14 August 2017

# **victorian transmission system access arrangement revised proposal.**

## **submission response to draft decision.**

Figure 4-1 – Warragul lateral expansion project management and commissioning staff allocation

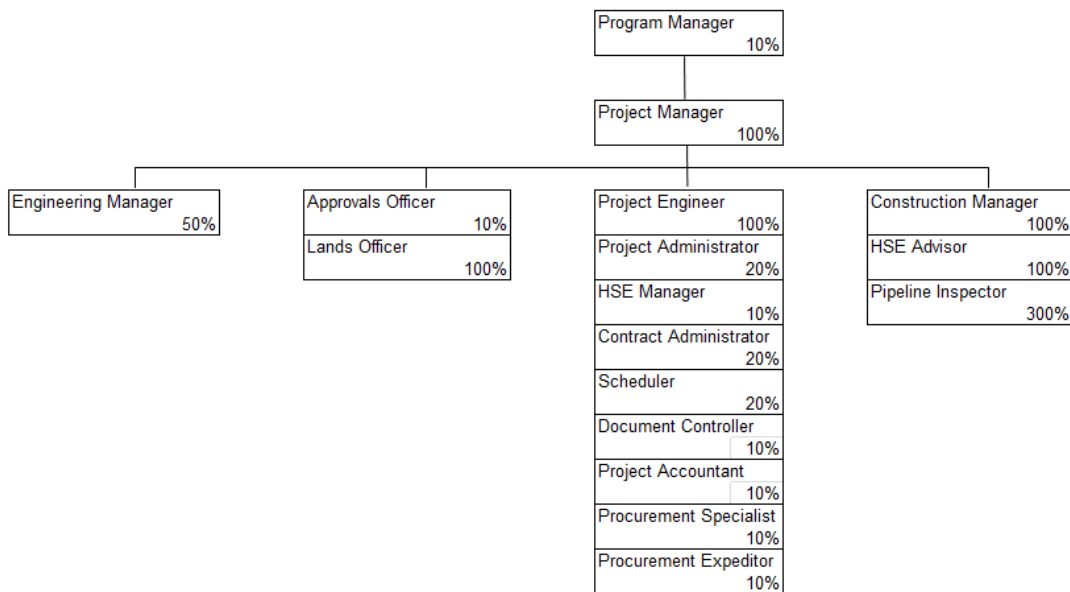
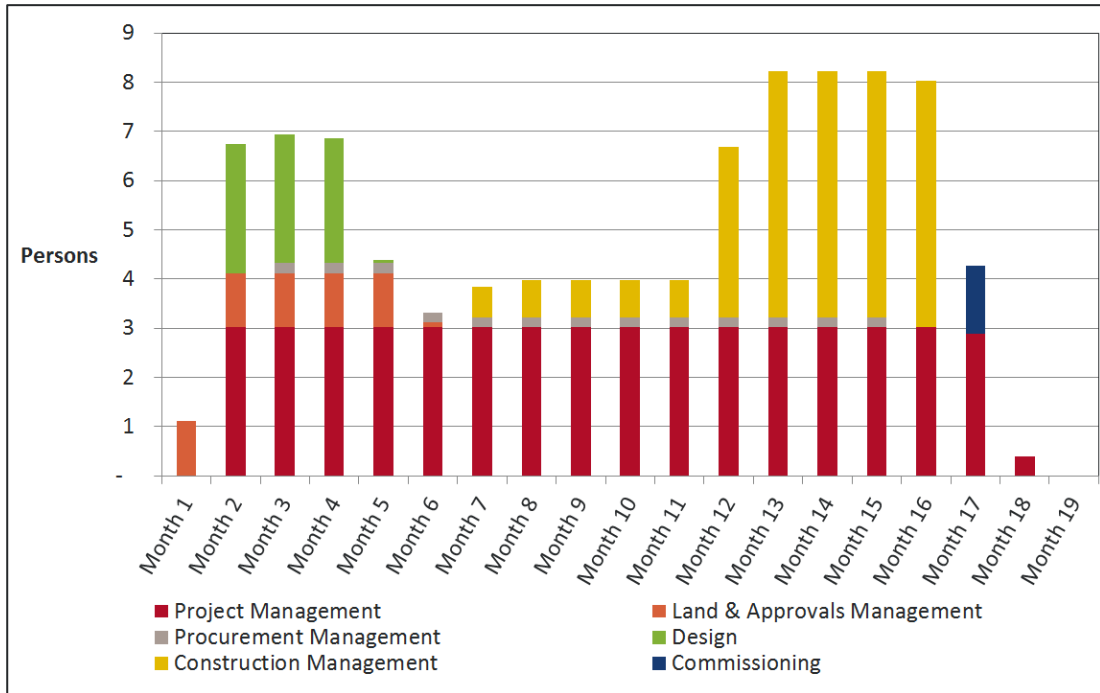
The allocation of project management staff time to this project is set out in Figure 4-1. The profile of staff time to specific project management and commissioning tasks is set out in Figure 4-2.
